**CITY OF AUSTIN – DEVELOPMENT SERVICES DEPARTMENT
SITE PLAN APPLICATION – MASTER COMMENT REPORT**

CASE NUMBER: SP-2019-0297C
REVISION #:
CASE MANAGER: Jeremy Siltala
UPDATE: U1
PHONE #: (512) 974-2945

PROJECT NAME: 218 South Lamar
LOCATION: 218 S LAMAR BLVD

SUBMITTAL DATE: February 13, 2020
REPORT DUE DATE: February 28, 2020
FINAL REPORT DATE: March 2, 2020 (3 days have been added to the update deadline)

1.10.0 CLEARANCE AND SAFETY REQUIREMENTS

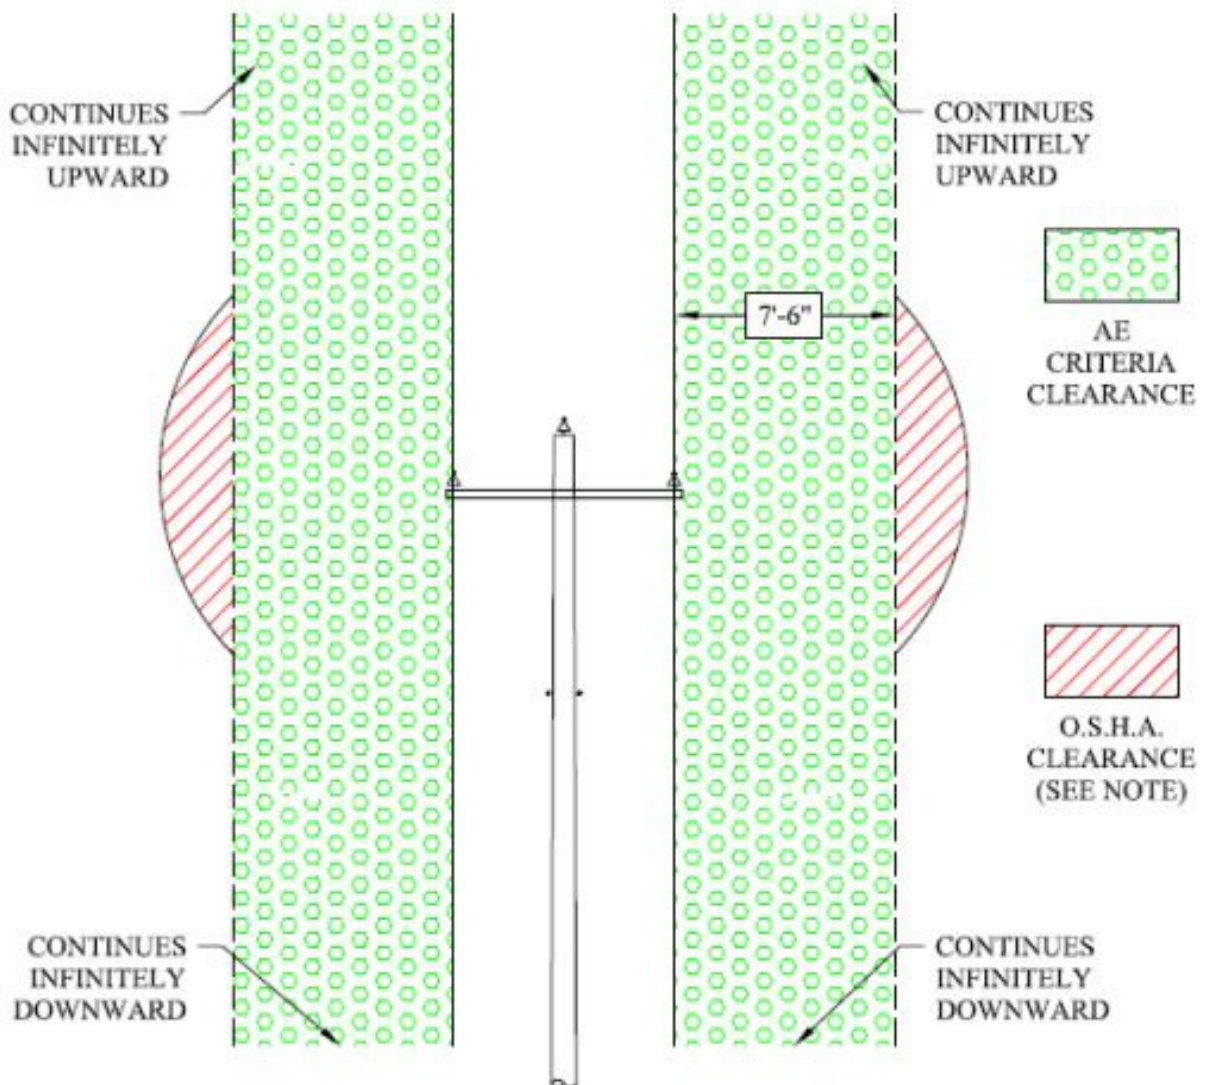
EL2. There is existing overhead facilities with a partial easement currently serving the adjacent property and the following clearance is required and needs to be shown and clear of the existing easement.

See the Austin Energy Permanent Clearance Envelopes and the OSHA/TxHSC Working Clearance Envelopes shown in the diagram below and in the Appendix C - Exhibits, Figures 1-34, 1-35, and 1-36. (Also see Section 1.10.6 for service drop clearances and Section 1.10.7 for clearances from swimming pools). These include, but are limited to, clearances from Customer's buildings, parking garages, light poles, signs, billboards, chimneys, radio and television antenna, tanks, and other installations. As required by AE Design, the Customer shall provide AE with a survey showing the proximities of the Customer's existing and/or proposed facilities to existing AE primary voltage facilities. For more information, contact AE Design.

NOTE: Customer is responsible for determining and ensuring that OSHA clearance are met during construction and maintenance of their facilities. In some instances, it may be necessary for the Customer to request (and pay for) AE to relocate AE facilities or to have the electric power de-energized before working near AE facilities, where possible. Scenarios will determine the possibility of relocating or de-energizing AE facilities.

UPDATE: Cleared. The existing overhead service is proposed to be rerouted. Cleared PLEASE keep in mind vertical construction is not allowed near energized electrical facilities until it has been de-energized.
